**Lenovo (Shanghai) Electronics Technology Co., Ltd.**  
**No. 68 Building, 199 Fenju Road, Wai Gao Qiao FTZ , Shanghai , China**  
**Tel: 86-18101020956; Fax: 86-10-58863918**

## Product Equality Declaration

We, Lenovo (Shanghai) Electronics Technology Co., Ltd. declare on our sole responsibility for the product of **501LV,502LV** as below:

### Diff in Ant Pattern

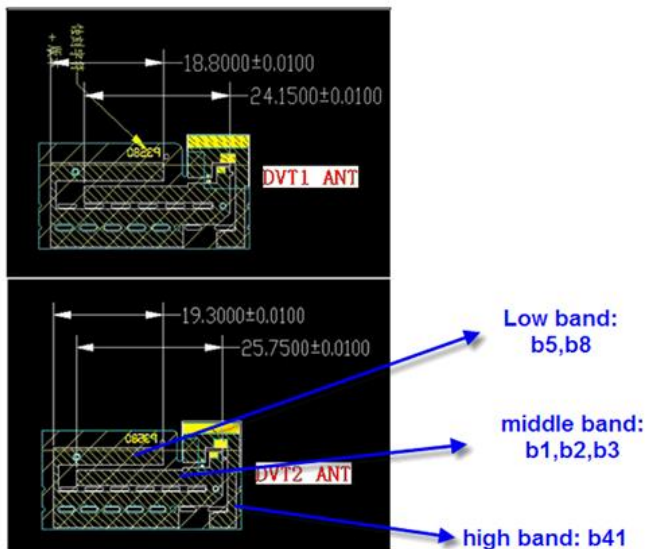
- ◆ Enable Tablet receiver by software
- ◆ Adapter change from Soft Bank ZTDAC 1(1A), ZTDAD1(1.8A) to C-P62(1.5A)
- ◆ WWAN Antenna changed as below:
  - (1). DVT2 Antenna Pattern is longer than DVT1, but the max Gain value keep same
  - (2). Antenna area is bigger
